SUBJECT: Forwards response to NRC 930902 telcon RAI re NRC Bulletin
 88-008, "Thermal Stresses in Piping Connected to RCS." Revs
 Calculation 13-MC-ZZ-643, "Auxiliary Spray Line Thermal
 Stratification" also encl.

Subject: Palo Verde Nuclear Generating Station (PVNGS)
Units 1, 2, and 3
Docket Nos. STN 50-528/529/530
Response to Telephone Request for Additional Information
Regarding NRC Bulletin 88-08
File: 93-005-419.05; 93-056-026

**RESPONSE TO NRC REQUEST FOR
ADDITIONAL INFORMATION**

EVALUATION OF THE PVNGS SAFETY INJECTION LINE FOR NRC BULLETIN 88-08

FIGURE 1

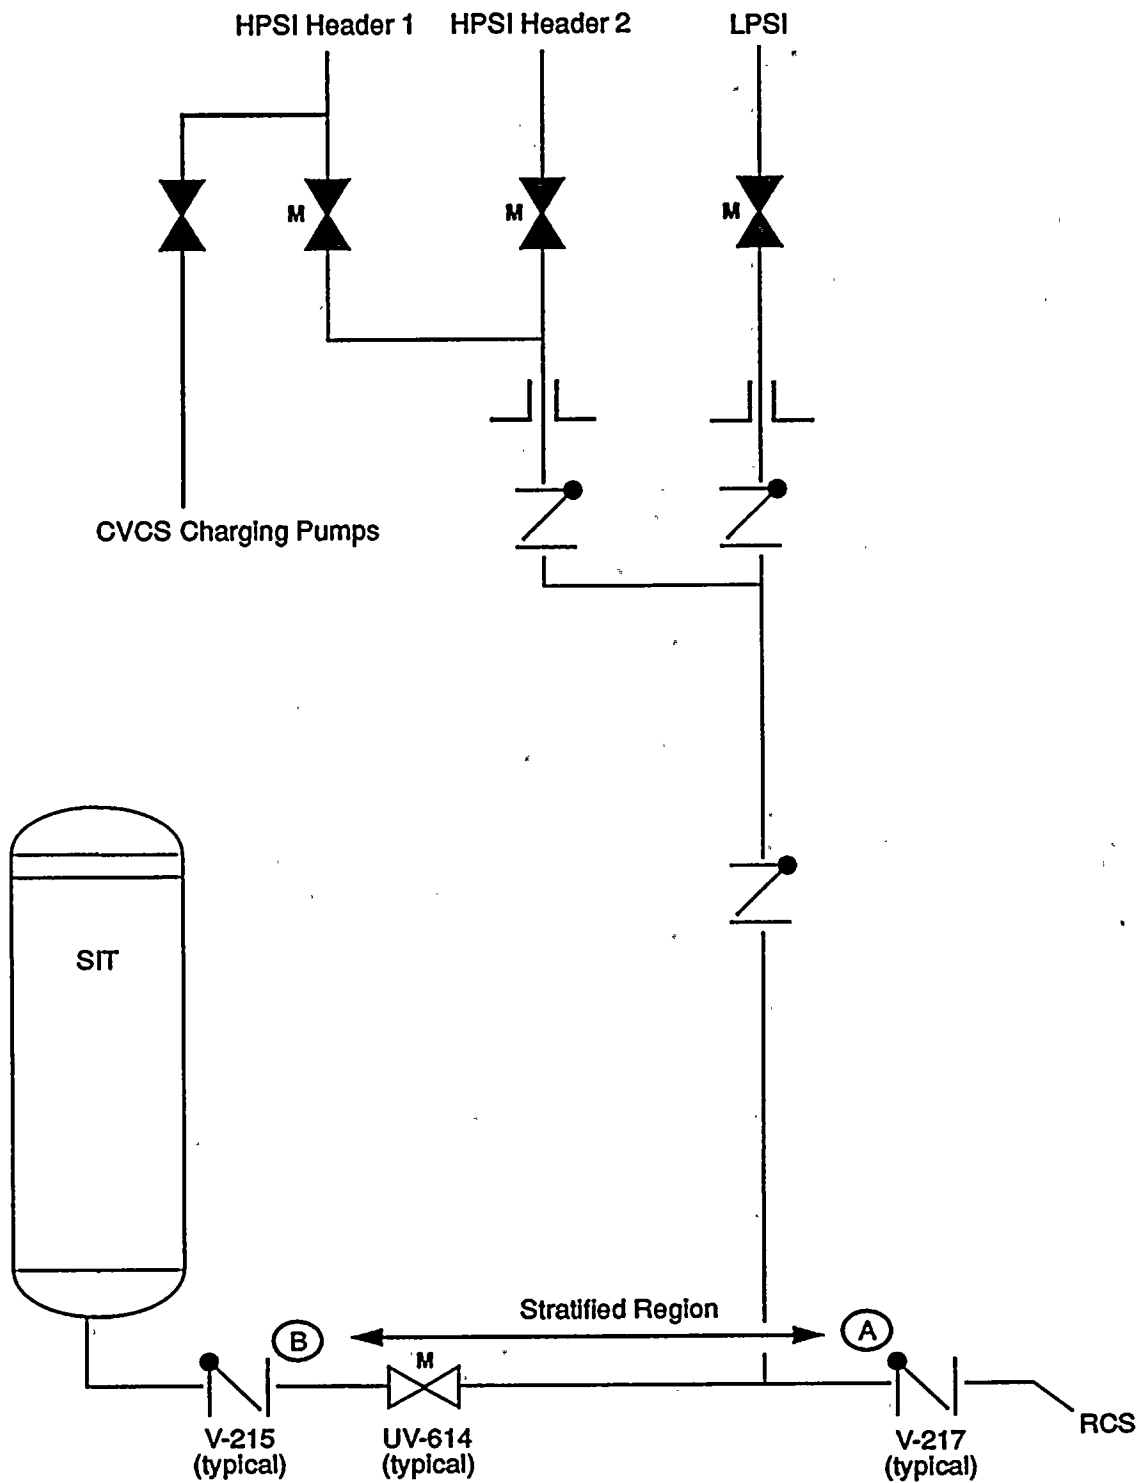
- 1) Diagram of the safety injection line connections to RCS, together with a description of the natural convection phenomenon that leads to thermal stratification in the horizontal section of the line,
- 2) APS' calculation of the bounding thermal stratification stresses in the auxiliary pressurizer spray line (APS Calculation # 13-MC-ZZ643), and
- 3) APS' schedule to implement the long term surveillance plan in Unit 3.

The safety injection lines at PVNGS provide a flow path to the RCS from the emergency core cooling system (ECCS) low pressure safety injection (LPSI) and high pressure safety injection (HPSI) pumps and from the safety injection tanks as shown in Figure 1. During normal power operation, the RCS pressure is sufficiently higher than the shut-off head of the HPSI pumps and injection is impossible in the event the pump(s) are in operation. Note also that the containment isolation motor operated valves isolate the ECCS pumps from the RCS. The piping segment between the isolation check valves is also connected to the chemical volume and control system (CVCS) via HPSI header 1. The charging system, along this flow path, is isolated from the safety injection line by a normally closed manual isolation valve and a normally closed containment isolation valve which, by procedure, is leak rate tested. Consequently, neither the ECCS pumps nor the charging pumps present the potential for in-leakage induced thermal stratification.

As a result of RCS isolation from the high pressure CVCS systems, conditions are more favorable for thermal stratification by RCS out-leakage (into the branch line). However, a torturous flow path precludes RCS out-leakage; there are 3 in-line check valves and 1 motor operated containment isolation valve that separate the ECCS injection headers and the RCS. Further, no flow path exists from the RCS to the corresponding safety injection tank as the system is closed. The segment of injection piping between the safety injection tank isolation check valve and the RCS isolation check valve is equipped with a 1.0" drain line and isolation valve. In the event of leakage past the RCS isolation check valve, the control room receives a high pressure alarm and the accumulated pressure is procedurally relieved through the 1.0" drain line. The occurrence of safety injection line high pressure alarm is extremely infrequent indicating the absence of RCS out-leakage.

In the absence of a flow path to support out-leakage of the relatively hotter RCS fluid into the stagnant injection piping, an initial evaluation concluded that the safety injection piping would not experience thermal loading beyond that defined in the original plant design. However, a mechanism does exist in which static loads develop linearly with increasing power level and corresponding RCS temperature. This mechanism has been identified as natural convective counter-currents that are established as a result of the high temperature difference between the ends of the stagnant body of water within the injection line between the RCS isolation check valve (V-217 typical) and the safety injection tank isolation check valve (V-215 typical).
